System Impact Assessment Report

CAA ID: 2013-498
Project: NRC TS Replacement

Applicant: Hydro One Networks Inc.

Date: December 2, 2013

Figure 1: Single Line Diagram for NRC TS

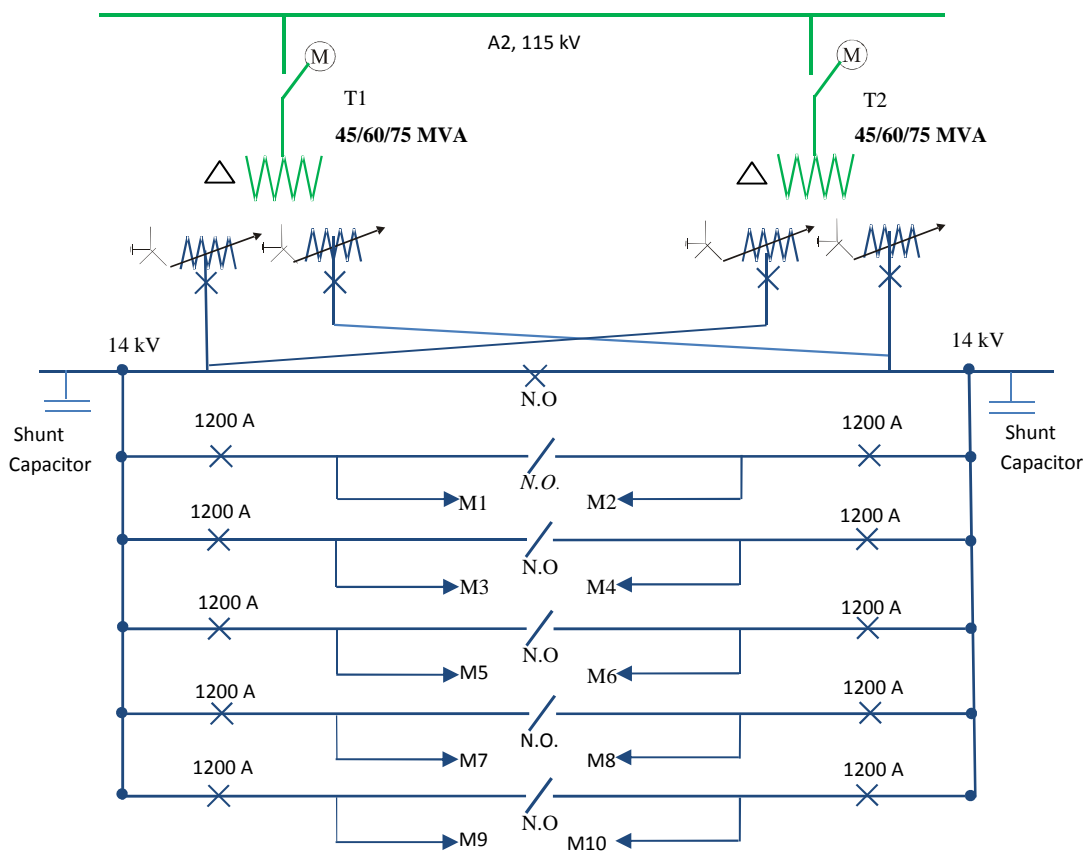
6. The proposed 115 kV disconnect switches have a rated symmetrical short circuit capability of 38 kA which is sufficient under the current system conditions but below the maximum short circuit level for 115 kV systems of 50 kA as indicated in the Transmission System Code. Should future system upgrades result in short circuit level increase the applicant will be responsible to upgrade the disconnect switches to withstand short circuit levels up to 50 kA.

As indicated in the Transmission System Code, the maximum short circuit level for 115 kV systems is 50 kA. The short circuit capability of this disconnect switch is sufficient under the current system conditions but below 50 kA. Should future system upgrades result in short circuit level increase the applicant will be responsible to upgrade the disconnect switches to withstand short circuit levels up to 50 kA.

Figure 3: Historical Load Power Factor at NRC TS

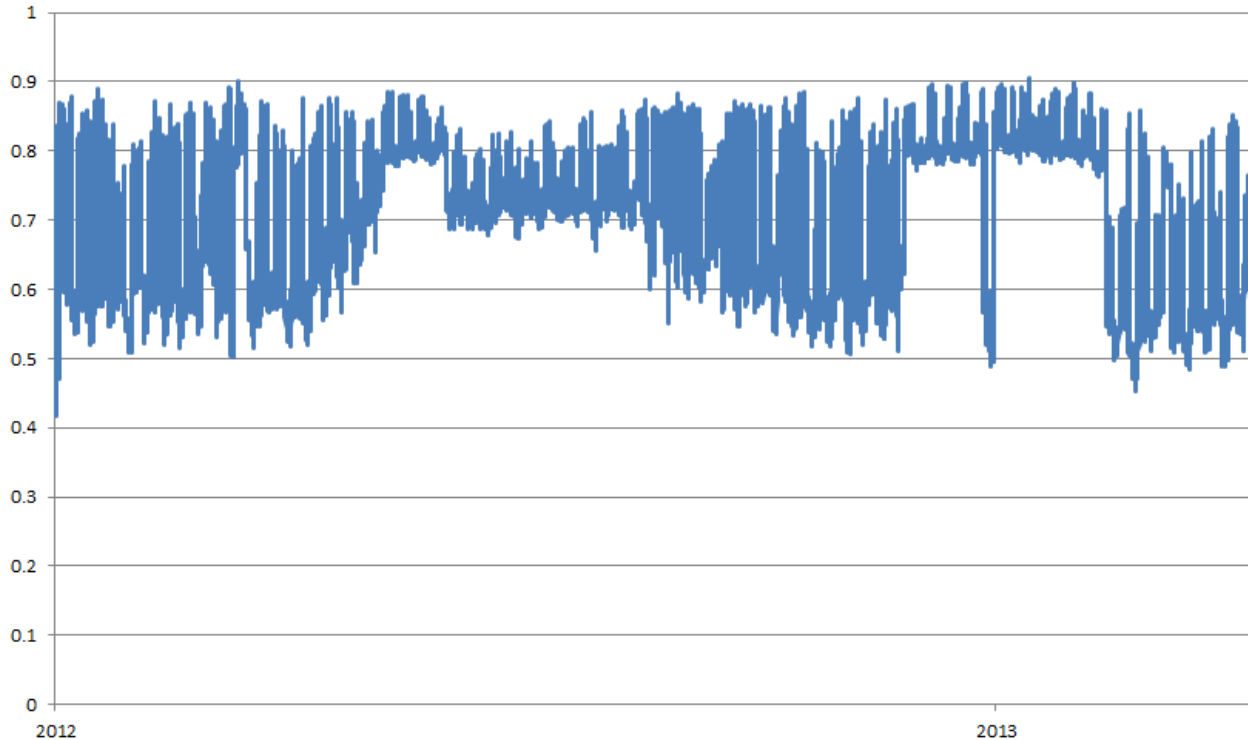
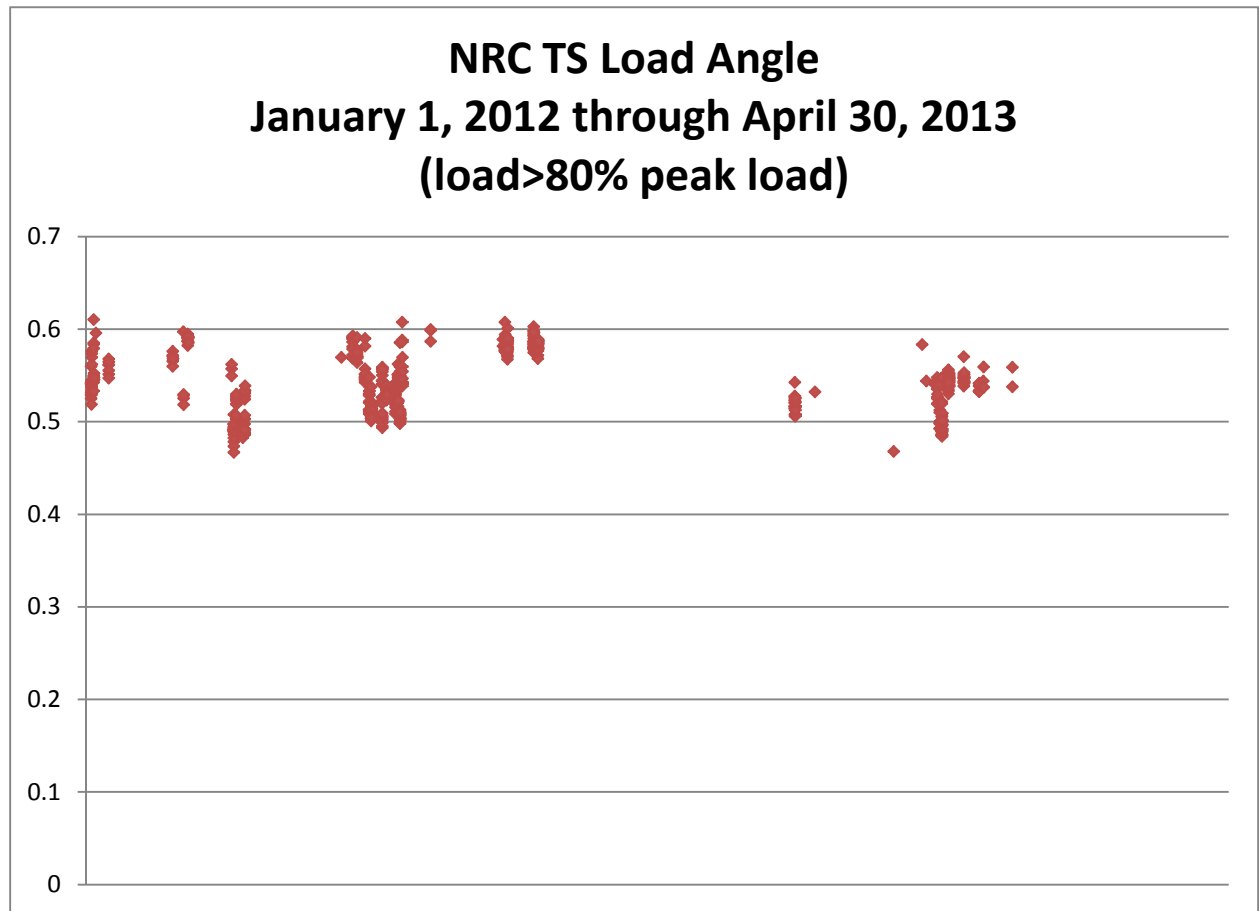
2. The power factor at the existing NRC TS does not meet the Market Rules requirements and a small amount of reactive power compensation would be needed to meet the reactive power requirements at the defined meter point. The connection applicant should monitor the power factor at the station and ensure that the reactive power is compensated to meet the power factor requirement.

It can be found from Figure 3 that the power factor was almost always below 0.9 and the lowest power factor value was approximately 0.5. Upon further analysis it was observed that the power factor got better with the higher load. The low power factor (less than 0.6) occurred only during off peak load conditions where the load is less than 3.5 MW. The historical load angles for instances when the load is greater than 80% of the peak load are shown in Figure 4. During peak load periods, the power factor was above 0.8 for the loads higher than 10 MW and above 0.83 for loads higher than 15 MW.

Power flow studies were performed to determine the amount of shunt capacitors needed to be installed at NRC TS assuming a power factor of 0.83 for a load of 18 MW. As a result, an amount of 3 MVar of static capacitive reactive power compensation would meet the reactive power requirements at the defined meter point. The applicant is required to monitor the load power factor at the station and ensure it meets the market rules requirements.
